ANALYSIS OF IBOC DAR SYSTEM PROPOSALS

Analysis of USADR IBOC DAR System Modifications and Their Impact on Performance

CONSUMER ELECTRONICS MANUFACTURERS ASSOCIATION
a sector of
ELECTRONIC INDUSTRIES ASSOCIATION

FIGURE 2 AT&T/AMATI WITH USADR ITU PROPOSAL OVERLAID

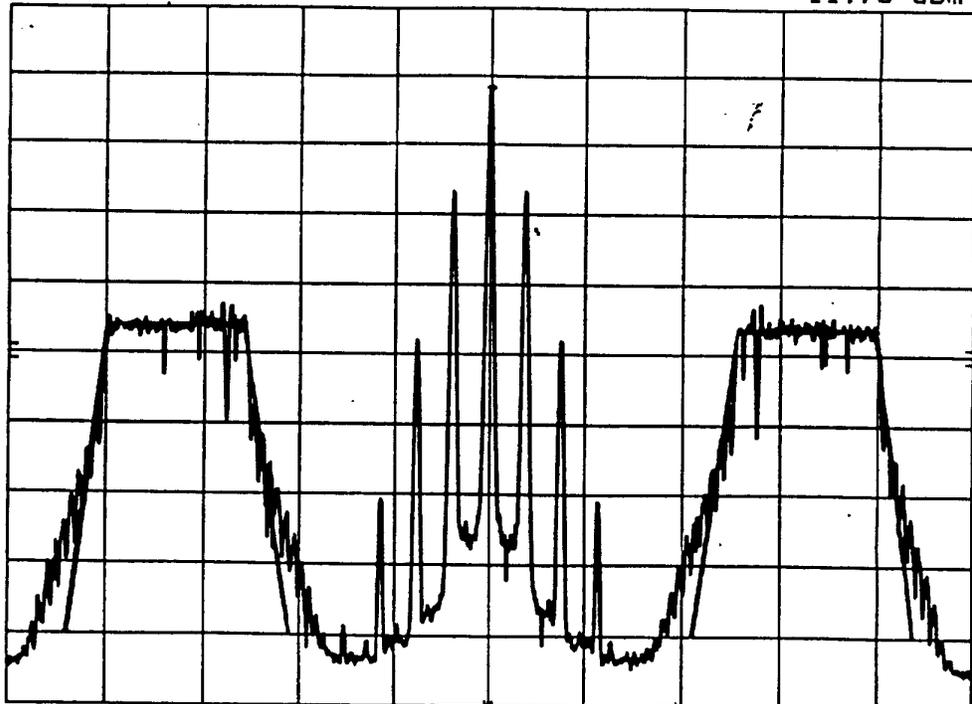
As with the Westinghouse proposal the complete digital signal is duplicated in each sideband. The system will operate on the alternate sideband when 1st and/or 2nd adjacent interference is present. To reduce digital interference to host FM, the two independently modulated digital signals start at ± 129 kHz and extend ± 200 kHz from the FM channel center frequency. This avoids the 114 kHz interference band described in the compatibility section (II) of this paper. To further reduce interference to the adjacent analog channels, the power of the independent sidebands will be determined by a compromise between digital coverage and adjacent channel interference. Figure 2 is a plot of AT&T/Amati System with the proposed system overlaid.

To avoid noise this proposal avoids the 114 kHz band by starting the digital signal at 129 kHz and running it up to 200 kHz above and below the carrier. This avoids the 114 kHz band but transmits a full level signal at 119 kHz. The compatibility tests show that the receivers are also sensitive to the 190 kHz band and avoiding only the 114 kHz band will not solve the IBOC digital -> to host analog compatibility problem.

FIGURE 3 USADR FM-1 SYSTEM

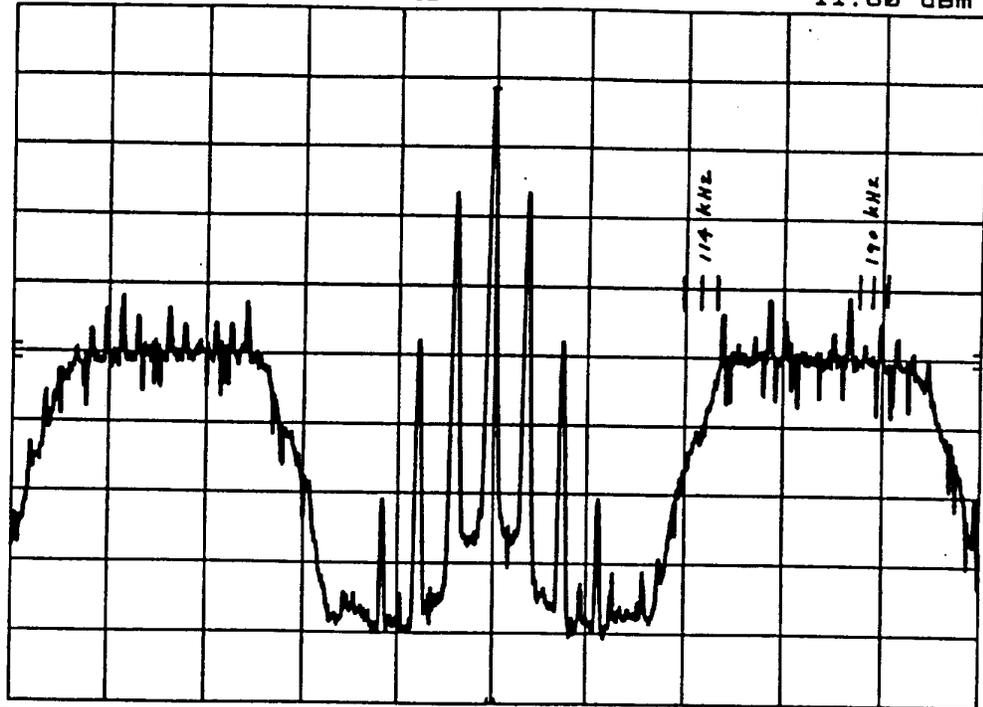
The IBOC digital signal is located in a 100 kHz wide sideband that runs from 120 kHz to 220 kHz above and below the FM channel center frequency for a total composite channel bandwidth (3 dB) of 440 kHz. The digital signal average power was set at 15 dB below the host FM for the laboratory tests. Figure 3 is a spectrum analyzer plot of this system's composite baseband signals.

Figure 4 shows a plot of the AT&T/Amati IBOC signal, and Figure 3 the FM-1 systems. The digital PSD for both systems is shown. The 114 kHz and 190 kHz PLL receiver sensitive bands are noted on the upper sidebands. The AT&T/Amati plot (Figure 4.) shows that at 114 kHz the digital signal is down by 23 dB, and at 190 kHz the digital signal is at full amplitude. It can also be seen on the FM-1 plot (Figure 3) that the 114 kHz digital signal is 10 dB down, and the 190 kHz is at full amplitude. The results of the digital -> host analog test (Table 1.) show that even if the system avoided the 114 kHz band, the system had similar noise increase. It can be concluded that for the Amati/AT&T System the 190 kHz frequency band was the major contributor to the noise floor increase.

FIGURE 4 AT&T/LUCENT/AMATI DSB SYSTEM

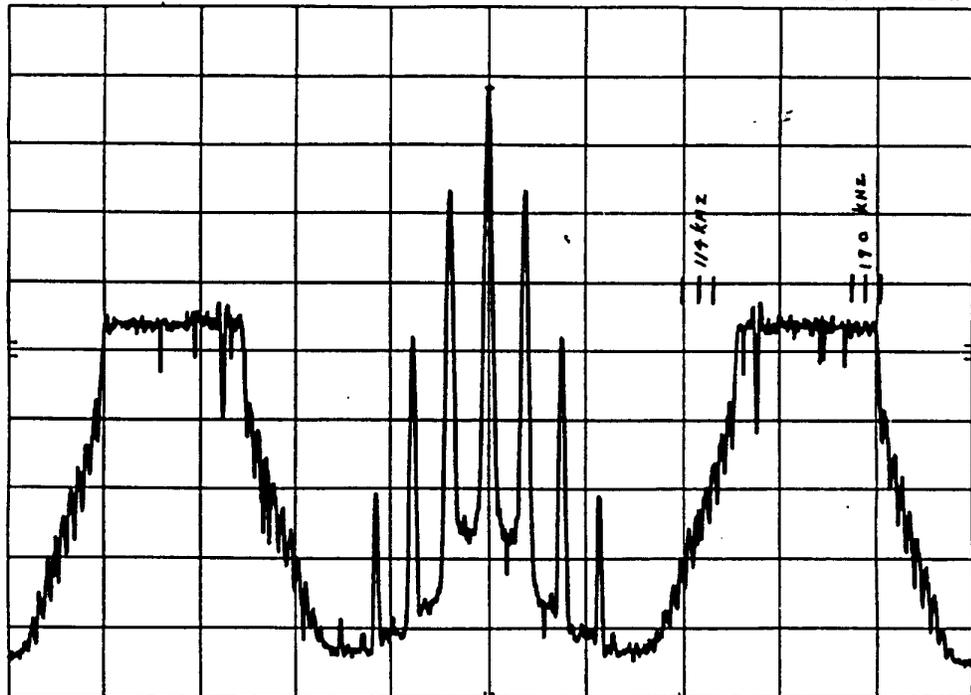
The digital signal is located in a 73.5 kHz wide sideband that runs from 126.5 kHz to 200 kHz above and below the FM channel center frequency. The total composite bandwidth is 400 kHz. The signal average power was set at 15 dB below the host FM. Figure 4 is a spectrum analyzer plot of the AT&T/Amati signal.

FIGURE 5 AT&T/LUCENT/AMATI LSB SYSTEM

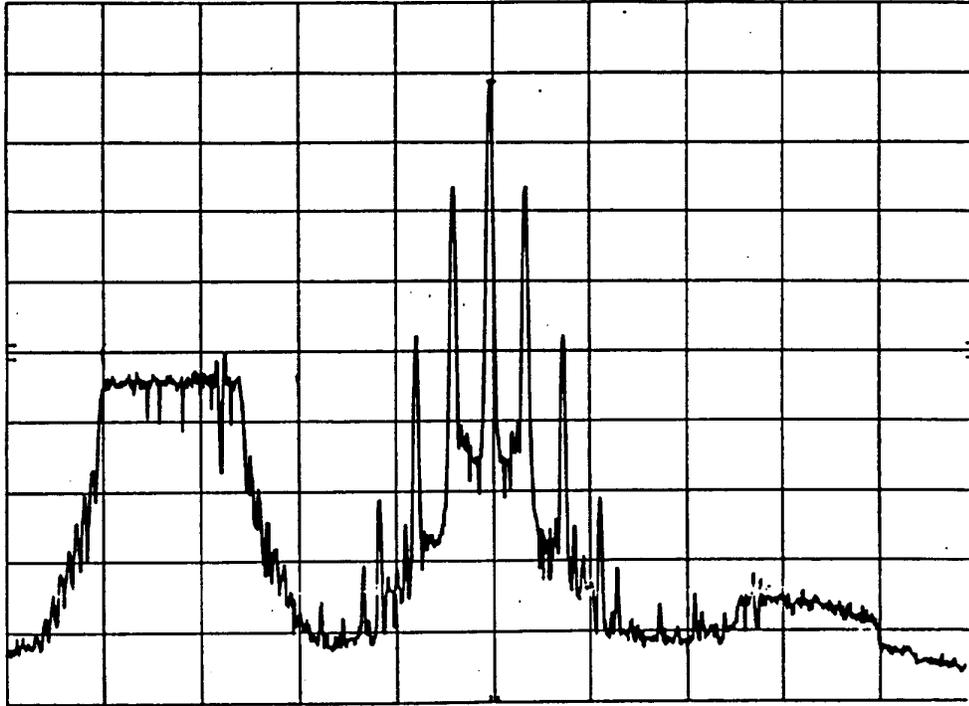
The second IBOC system proposed by AT&T/Amati was a single sideband IBOC system. By placing the complete digital signal on one sideband, this system is intended to work in situations where 1st adjacent channel interference is present on the alternate sideband. The equipment that was delivered to the DAR laboratory for testing was capable of operating in three modes, Double SideBand (DSB), Lower Sideband (LSB), or Upper Sideband (USB). The system was tested in the DSB and LSB modes. In Lower SideBand (LSB) mode the digital signal is transmitted in a single 73.5 kHz wide sideband that runs from 126.5 kHz to 200 kHz below the FM channel center frequency. The total composite bandwidth is 300 kHz. The signal average power was set at 24 dB below the host FM. The IBOC signal uses discrete multitone or COFDM modulation. In the LSB or USB modes, 18 subcarriers with 8-phase modulation is used. Digital audio coding is provided by the AT&T Perceptual Audio Coder (PAC) which operates at 128 kbps for the stereo audio digital channel. Figure 5 is a spectrum analyzer plot of the AT&T/Amati signal.
